Product Change Notification

New version of the Ultra-Slim 34 Series printed circuit board relay

New product EMR

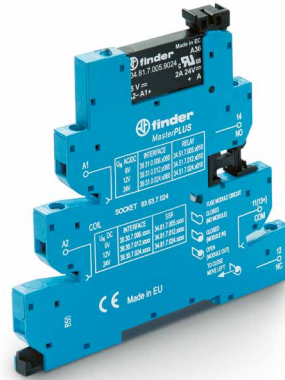
34 Series EMR new version

- From May 2017, the EMR relays will be produced with a black side to the cover on the front and translucent on the back
- The side of the relay is printed with the technical data, full product code and the Finder brand
- The top of the cover is printed with the Finder brand, relay type (EMR) and full product code
- The technical characteristics and approvals will remain the same as those of the previous types with the white cover.

New product SSR

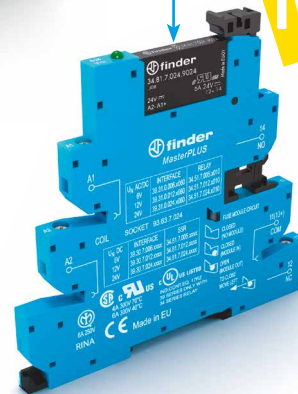
34 Series SSR new version

Since April 2017 the production of new types has been available - characterized by improved performance. In particular, types 34.81....9024 will see an improvement in controlled load; increased from 2 to 6A - 24VDC.

- The cover remains completely black, differentiating it visually from the EMR relays
- The side of the relay is printed with the technical data, full product code and the Finder brand
- The top of the cover is printed with the Finder brand, relay type (SSR) and full product code
- As with the previous types, cURus approval, with the new features, has been maintained.
